Giant Mine Environmental Assessment

Round Two Information Request Response

EA No. 0809-001

Alternatives North IR #01

Figure 5: Effluent Dilution from a Single Port for an Un-Stratified Ambient Water Column: (a) Open Water and (b) Ice Cover Periods (worst ambient conditions, with near stagnant current)

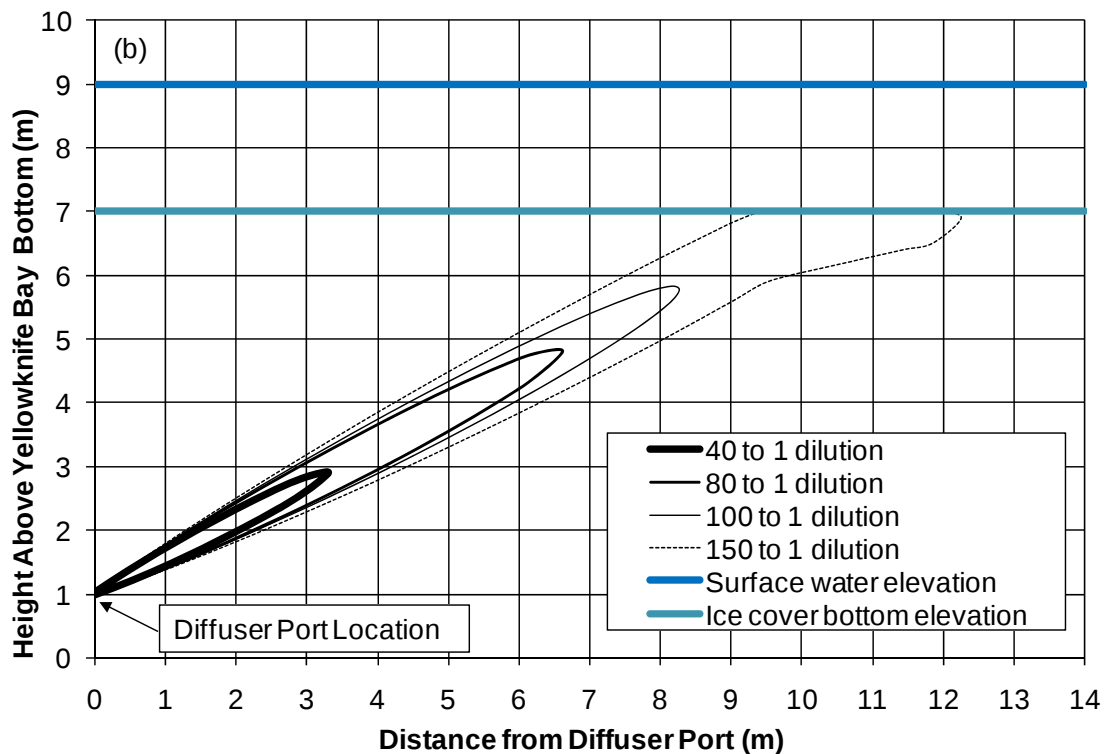
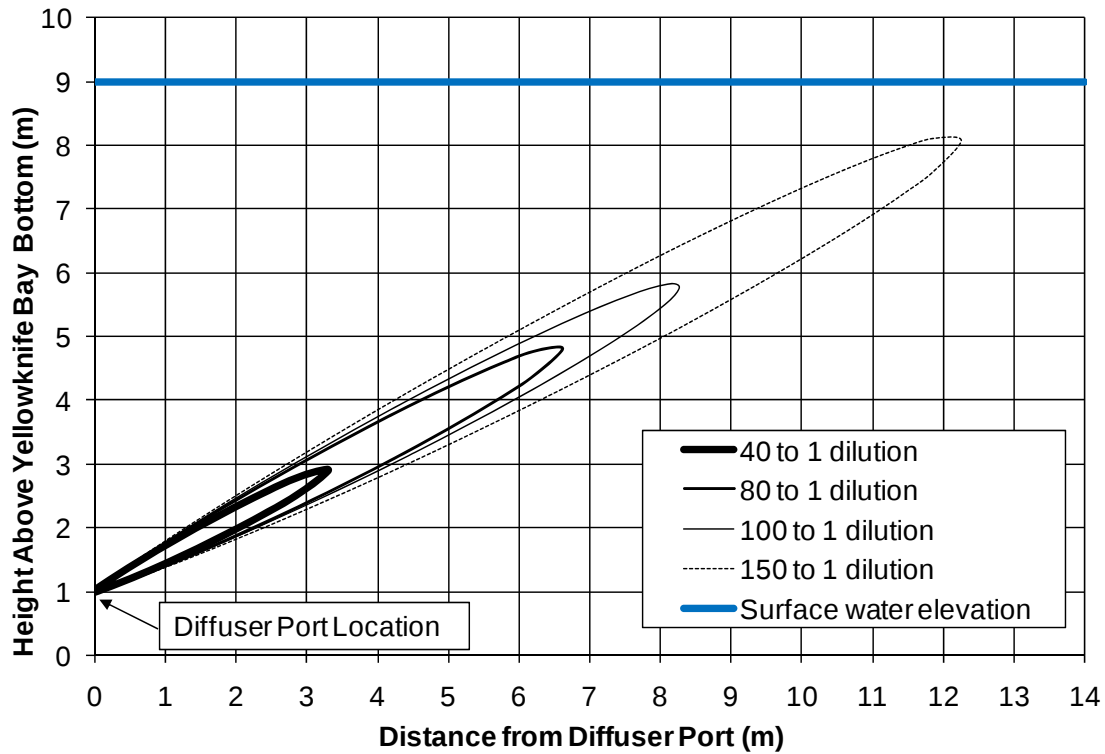
Please provide a summary of the diffuser design study promised during the Technical Sessions Day Two as recorded on pages 259-260 of the transcripts.

- When no temperature stratification is present in the bay, the plume jet from a port is predicted to make contact with the water surface or the ice cover. Model predictions nevertheless indicate that mixing of the effluent with ambient water would achieve the 150 to 1 dilution before the plume makes contact with the water surface during the open water period (Figure 5a). During the ice cover period, it is predicted that the plume would make contact with the ice cover bottom (Figure 5b).

- Uncertainty should be considered on dilution predictions after a plume makes contact with a barrier or interface (i.e., ice cover in Figure 5a or thermocline in Figure 6). The near field region, which is the domain of validity of CORMIX, ends when the plume reaches an interface. The length of the contact is however relatively short. As a result it is proposed that the mixing zone be slightly higher than the near field area, consisting of an area with a radius of 15 m around each port. During the detail design phase, adjustment should be made to the port angle to minimize the length of contact with any interface.
